ARCHITECT'S ADDENDUM

ADDENDUM NUMBER: 001

RE: City Hall Conference Room Remodel

Cordogan, Clark & Associates

Drawing M1.1:

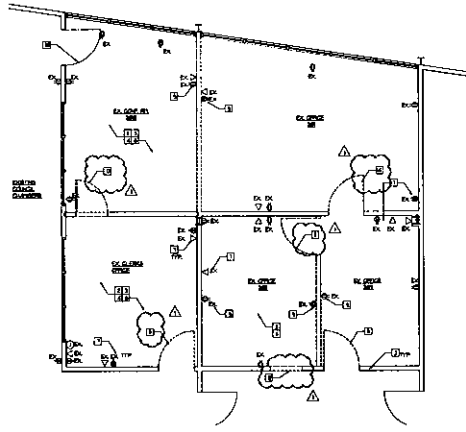
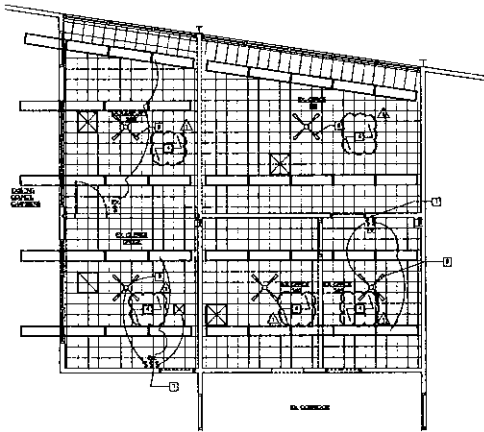
- Drawing has been revised to show existing ductwork, connection of new diffusers to existing ductwork, zone dampers, and replacement of existing exhaust fan.
- Alternate 02 information has been added to sheet M1.1.

A. Compact Mobile Storage will be contractor provided, and contractor installed.
6. Q. *Mechanical plans do not show the mains that we are disconnecting the existing ducts from and attaching new to. Will there be a decent view of duct above ceiling at the walk thru? From drawings we are unable to figure out the intent to create the separate zones. Could existing Main be shown, and are there existing drawings available?*

A. Existing ductwork has been shown. Refer to sheet M1.1.
7. Q. *Where the is the main supply duct located that we will be able to tap into for the new zones designated on the drawings?*

A. Refer to sheet M1.1.
8. Q. *There are no existing returns in the space; are new returns just transfers to the ceiling space? If so, do we need any duct on top of new returns to eliminate sound transfer?*

A. Existing return is located at exterior walls. Transfer boot to be provided on new return. Refer to sheet M1.1.
9. Q. *Workroom 202 does not have a new zone thermostat shown, so it must be fed from on of the other three proposed zones; which zone would you like it fed from?*

A. Workroom 202 to be zoned with adjacent office. Refer to sheet M1.1.
10. Q. *What is the height from existing ceiling to the deck at the area where the new beam supports are to be installed?*

Drawing 1/A1.1: (refer to attached revised drawing)

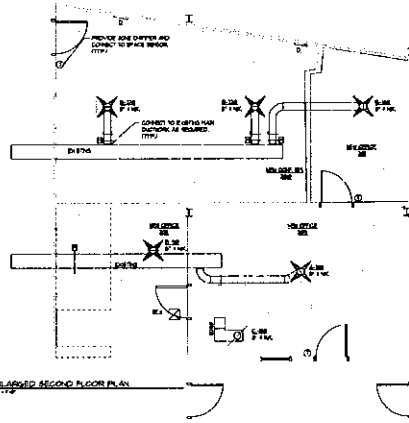
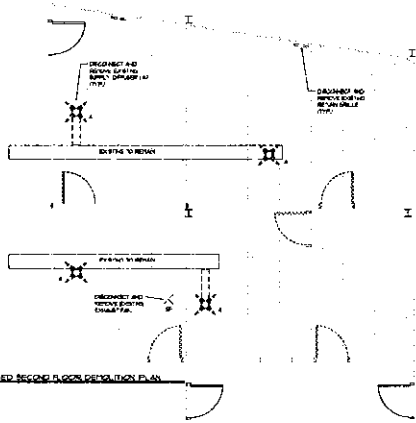
- CHANGE keyed note "5" to "13" at door between Ex. Conf RM and Ex Clerks Office.
- CHANGE keyed note "11" to 5" at door from hallway to Ex. Clerks Office.
- CHANGE keyed note "10" to "11" at door to Ex. Office 202.
- ADD keyed note "14" to Ex. Office 201 door.
- ADD keyed note "12" to Ex. Office 202 wall adjacent to corridor where new pass-through window is to be installed.
- ADD Demolition Keyed Note "12" to read as follows: "Demo & prep wall to accommodate new pass-through window."
- ADD Demolition Keyed Note "13" to read as follows: "Remove existing door and hardware in its entirety, salvage door to be re-used for door A201."

- ADD Demolition Keyed Note "14" to read as follows: "Remove existing door and hardware in its entirety, alvage door to be re-used for door A202."

1. Q: *Is there a project cost estimate available?*
A: The estimate of construction cost is under \$85,000, excluding alternates.
2. Q: *Sheet A1.1 Demo Note 11: Where this door is being removed, are we to infill wall with gypsum assembly? Also the door and hardware are called out to be re-used at Door A203; the the hand/swing of door is opposite, please clarify.*

4. Q. *Sheet A1.1 shows demolition of 12x12 perforated metal ceiling and frame in rooms 200 and Ex Clerks Office. Sheet A2.1 Note 4 calls for New Ceiling in all areas. Is there ceiling removal in existing rooms 201, 202. Amd 203?*

19. Q. *Will we be able to place a dumpster on South Water Street near rear entrance?*
 A. Yes, coordinate final location with owner.
20. Q. *On Sheet A1.1 detail 1, the door on the wall between room 202 and 203 (key note 10) states the door is to remain but the wall is being removed. What is the intent with this door? Also is there a door change for new office A201?*

A: Yes, infill the wall with partition type "A" assembly. The door and frame to the to the existing clerks office (from hallway) is meant to be demoed in its entirety. Refer to revised Sheet A1.1.

A. Yes, all 12x12 perforated metal ceiling is to be removed in rooms listed in project scope. Refer to revised Sheet A1.1.
5. Q. *Sheet A3.1 Furniture Keyed Note 1; do we provide and install the "Compact Mobile Storage" or is this Owner provided?*

A. The door to existing A202 office is to be salvaged and reused as the door to A203 (from the hallway). The door to Ex Office 201 is to be salvaged and reused for the new Work Room 202. The door between Ex Clerks office, and Ex Conf. Rm 200 is to be salvaged and reused at New Office 201. Refer to revised Sheet A1.1.
